SERVICE BULLETIN

Effective Date: MAY 2016
Log Number: CMA-PI-470
Subject: HEATER MODIFIED CONNECTION
Model Affected: GL-X

GL-X Heater Modified Connection

PREVIOUS HEATER CONTACTOR CONNECTION

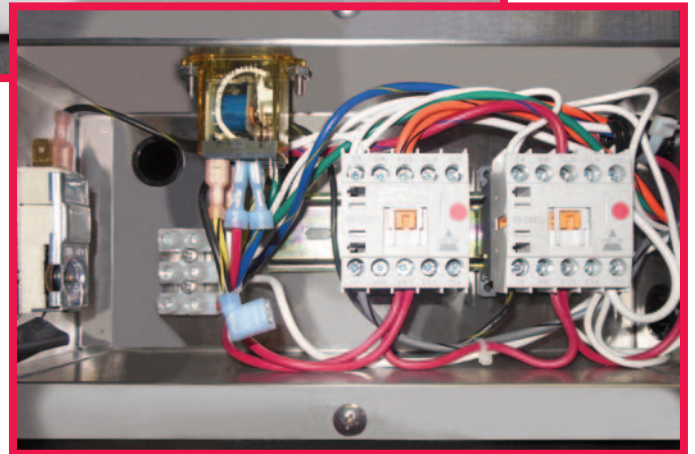
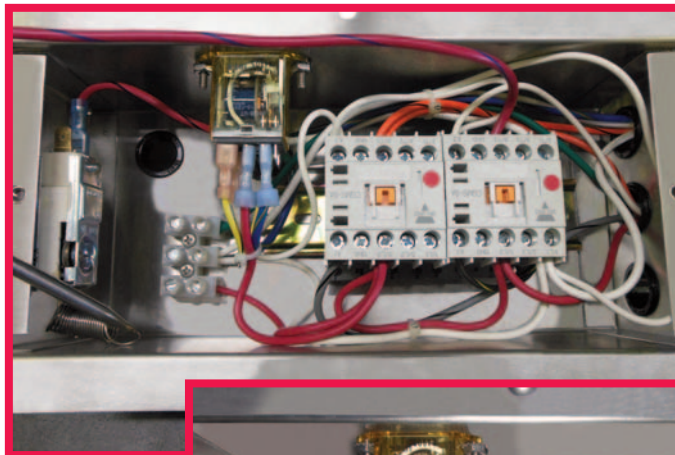
The Heater Contactor was directly connected to the Power Block and received power all the time. CMA's modified version will prevent the heater from operating if the operator accidentally does not turn off for the night, causing the water to evaporate out, and ultimately exposing the Heating Element to Air, and possibly "Dry-Firing". Once reconnected, the Heating Element operates properly and is completely safe. Field conversion instructions are included, showing our customers how to rewire the Heater Contactor by connecting the Heater Thermostat to the Coil, rather than to the Heating Element.
